RC Pylon Racing e- Technical Meeting Minutes 2020 Saturday October 17th 2020

Minutes by: Rob Metkemeijer, S/C chairman

1. F3E rules proposal 2020

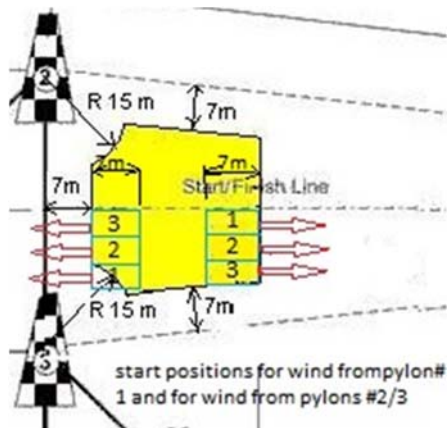
- 1.10.a. Change starting lane dimensions to: Each lane 3 meters wide and 7 meters long. See drawing below of pilots area and starting lanes for clarification. This drawing needs to be added in the rules (with better quality)

In the final drawing that will be published in the rules the suggested flight paths will be added for clarification. *In a discussion about this reverse start suggestions were made to delete it. The SC Chairman will initiate the discussion for a possible future rule change in the Sub Committee.*
